## **AMENDMENT TWO (2)**

**SUBJECT: IFB013BOCC17(C) Purchase & Installation of  
Perimeter Fence at Golden Grove Adult  
Correctional Facility & Detention Center, St.  
Croix**

ADDENDUM # 2

IFB013BOCC17(C) – Bureau of Corrections Security Fence Golden Grove,  
St. Croix

TYPICAL SECTION FOR TURNAROUND WITH ASPHALT SURFACE

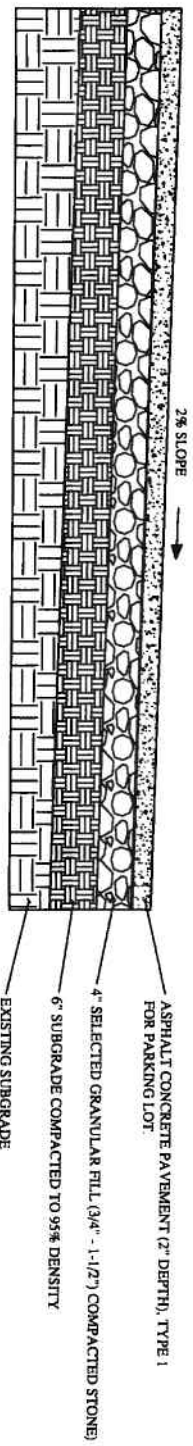
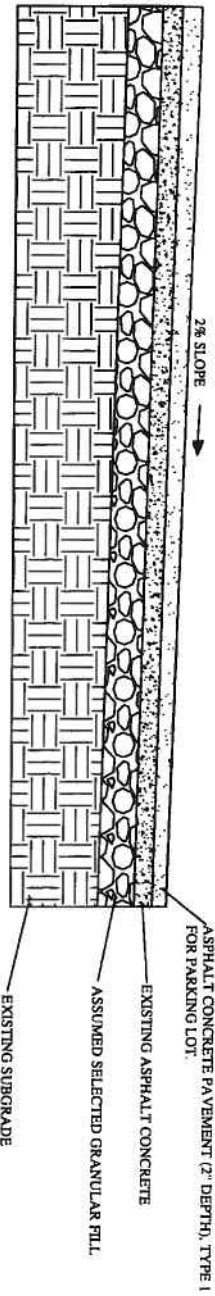
Question: Can you please provide a bituminous pavement detail showing base requirements? Since this will be a turnaround is there going to be compaction testing done? And if so at what percentage?

Answer: The present existing road will be a part of the turnaround. It will be however be widen to construct the turnaround. Only the extension of the road will have the granular road base of 4". The depth of the asphalt will be 2". A detail will be submitted.

PG-3

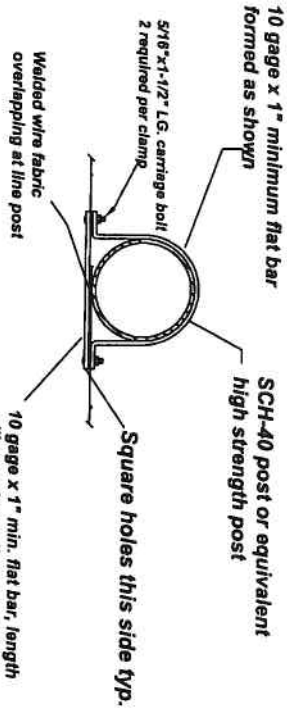
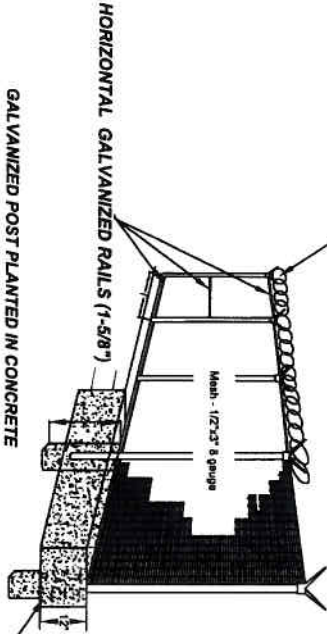
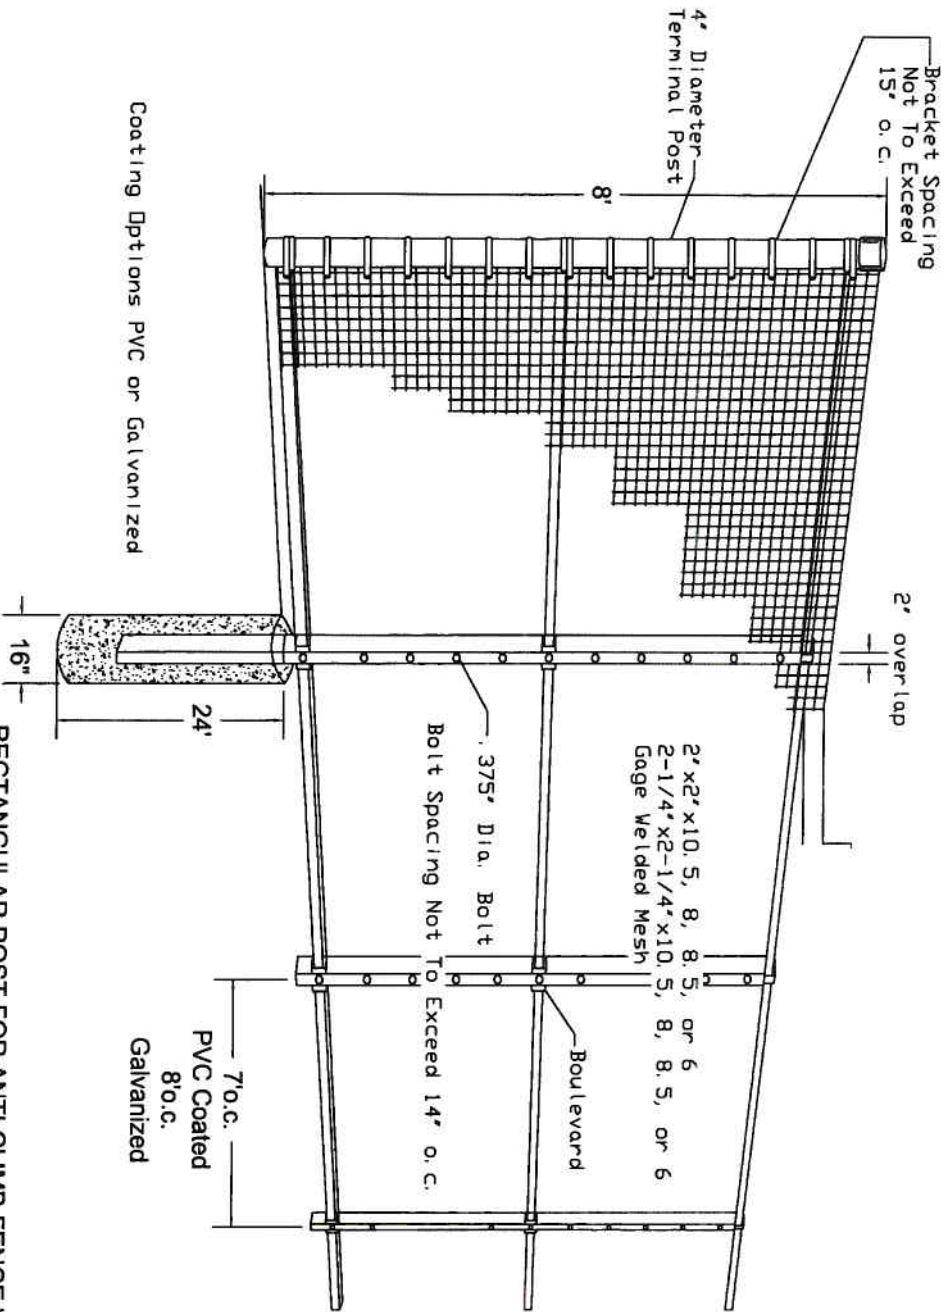
Question: On the drawing labelled PG-4 it specifies the installation of  
rectangular post for Anti-climb fence without footing, however there is a  
specific mention of 12" concrete footing that will be constructed under the  
fence to hold the wire in place. This information is rather conflicting, since  
on pG-3 under "typical fence detail" it shows the detail for an 8"x12"  
concrete footing. Please clarify?

Question: On the sheet labelled PG-3 there is a detail that shows the "connection to the fence post detail" however in this detail it shows a sch-40 round post. What are the required fence post? Is it the 3"x3" regular post or are sch-40 round post an option, and if so what is the diameter of the round post?

Question: On PG-3, the "post in concrete" detail is different to the same detail post in concrete detail on PG-4. Which detail is going to be used for this project?

Question: On PG-7 there is a detail which shows the horizontal rails as being rectangular, however on page 3 all of the as specified to be 1-5/8 round pipe? Which detail is going to be the standard for this project?

Answer: The security fence shall be constructed with a continuous 12" high  
x 8" thick footing. Therefore please refer to the detail on page 3. The label  
on page 4 says "Rectangular post for Anti-Climb fence without the footing".  
Again, this fence has a continuous 12"x8" footing.

Answer: This fence shall be constructed with the rectangular post.

Answer: The detail on page 3 will be used for this project with a concrete depth of 24" and a width of 16". The correction was already made in the drawing and will be distributed.

Answer: The horizontal rails shall be used for this project as shown on PG-7
